AMCA 301-06 Interpretation:

A request for clarification of the second paragraphs of both §5.3.1 and §5.4.1 was received by AMCA International' Technical Advisory Committee on Sound (TACOS). The following clarification was approved:

Interpretation Figure 1 - When Blade Pass Frequency (BPF) value (X_{BPF}) falls outside of a 2% band limit

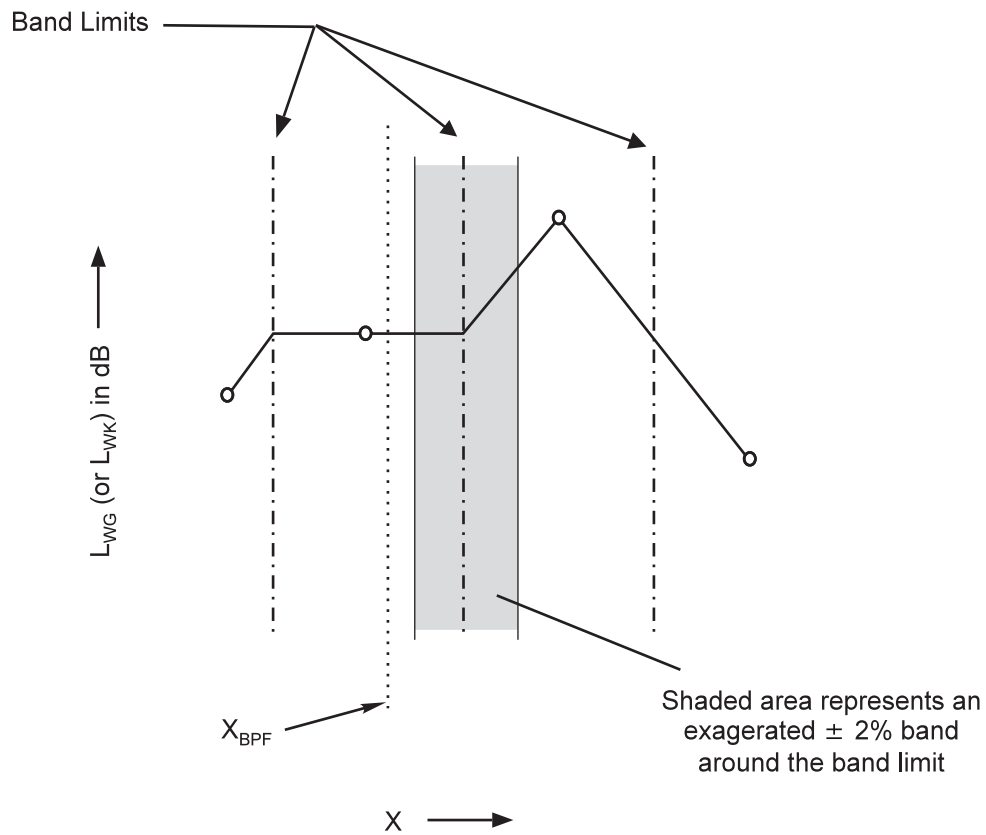
The fourth sentence in these two paragraphs (§5.3.1 and §5.4.1) should read, "If the blade pass frequency falls within ...of the two adjacent bands adjacent to that value using" Also, the addition of the following two figures would clarify the paragraphs.
